# Action Memo / EE/CA

## Contingent Removal Actions for Contaminated Soils

### Addendum 1: Structures

**Response to MMCIC/ EHS Technology Group, LLC Comments on the  
Action Memo/EE/CA for Contingent Removal Action  
for Contaminated Soils, Addendum 1: Structures,  
April 2004,  
Public Review Draft**

Figure 2.1 Location of Identified PRSs for this Contingent Removal Action (PRS 153, 266, 273, 276, 412, and 421 - Outlined in Red)

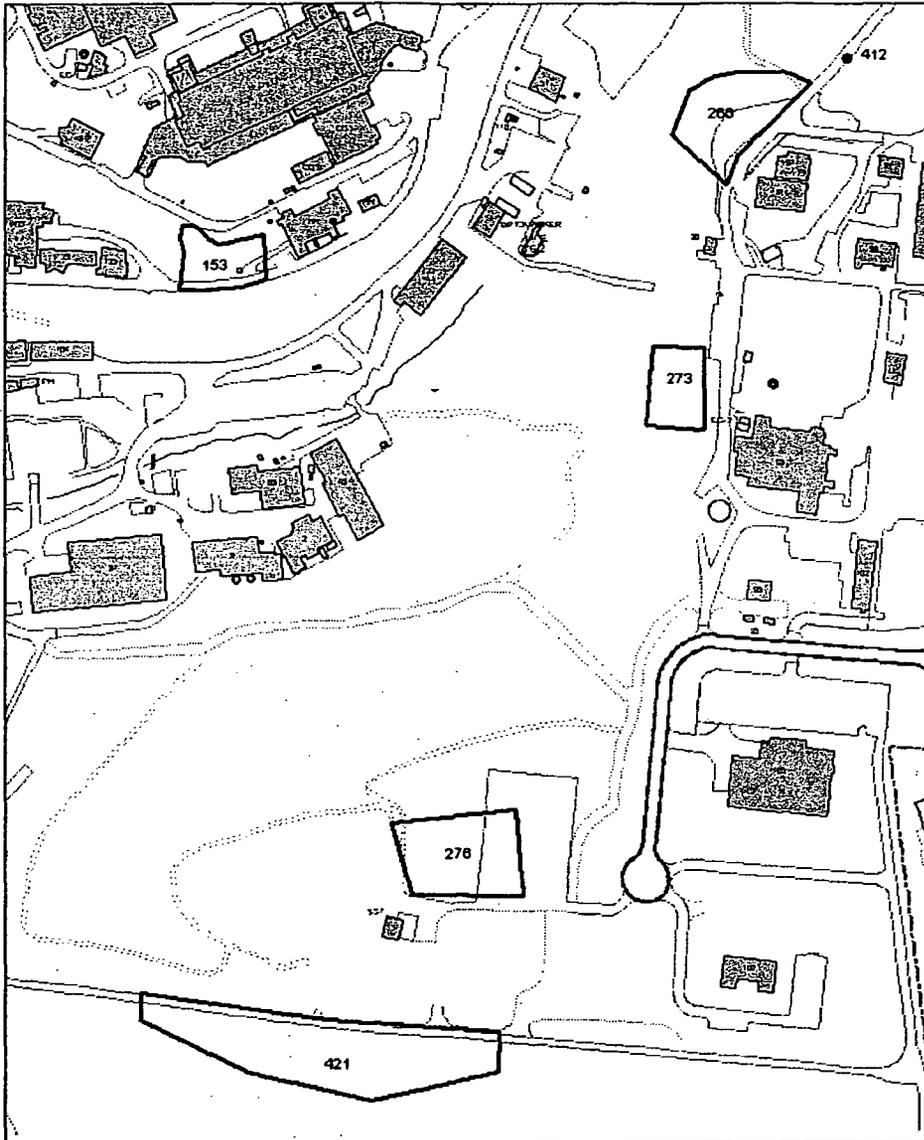
1. MMCIC concurs that a removal action is warranted for the areas identified as PRS 153, 266, 273, 276, 412, and 421, and that the combined AM/EE/CA for these areas, described in the above-referenced document, is an efficient approach that still meets the requirements of the CERCLA/Mound 2000 process. However, MMCIC is unclear how newly discovered cleanup areas will be addressed in the future. Will any newly discovered areas first become a PRS and go through the binning process for removal, or will these designated sites go directly for removal action in accordance with the guidelines in this action memorandum? MMCIC intends to ask for a briefing with DOE and BWXTO, with Mr. Jim Bonfiglio of MESH in attendance, to clarify this process.

When information that indicates possible contamination becomes available, it is assessed by the site and regulators. In the past, this has resulted in the identification of new PRSs. If the information indicated that this new PRS is similar to those identified in this AM/EE/CA, then removal action in accordance with the guidelines in this AM/EE/CA is warranted.

The briefing mentioned above took place on November 7. As a result of that discussion, a flowchart of the process for newly discovered sites was developed and is included in these responses.
